No. EL/11.5.5/21

Modification Sheet No. RDSO/2023/EL/MS/0495 (Rev. '0')

Provision of additional BLDJ switch by utilization of BLHO/ZBAN switch as additional BLDJ in three-phase electric locomotives (WAG9/WAP7/WAP5).

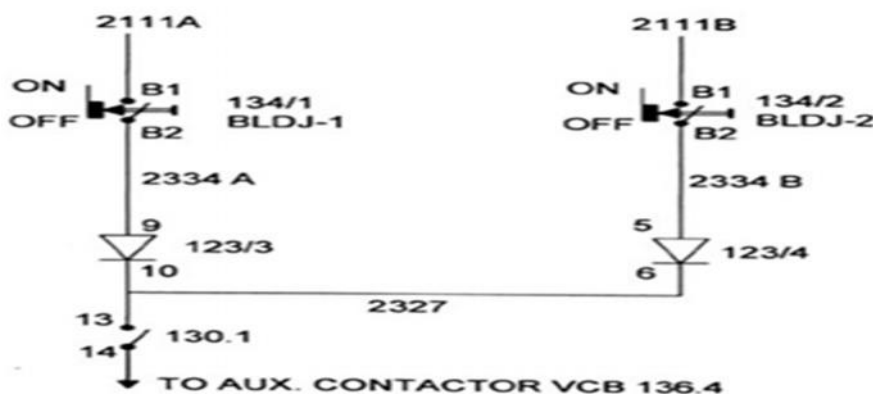
- 2.1** Zonal Railway reported that there are several cases in three-phase electric locomotives, wherein due to failure of BLDJ Switch (134) loco failed on line and Loco Pilot has to drive the Loco from rear cab with restricted speed to clear the block section.
- 2.2** To overcome the aforesaid problem, modification has been adopted in Eastern Railways by utilization of push button switch 161 (illuminated Push Button Configuration) provided in SB-1 panel as unused and in isolated condition. Modification has been done by using this switch (161) as BP2DJ to close VCB to avoid locomotive failure on line due to failure of BLDJ in any driving cab like conventional locomotives.

- 2.3** The main problem is in this modification for using switch No. 161 that it is located in SB-1 panel causing LP/ALP to go to SB-1 panel every time for operation. Also with this modification for opening of VCB, LP will have to lower the pantograph.
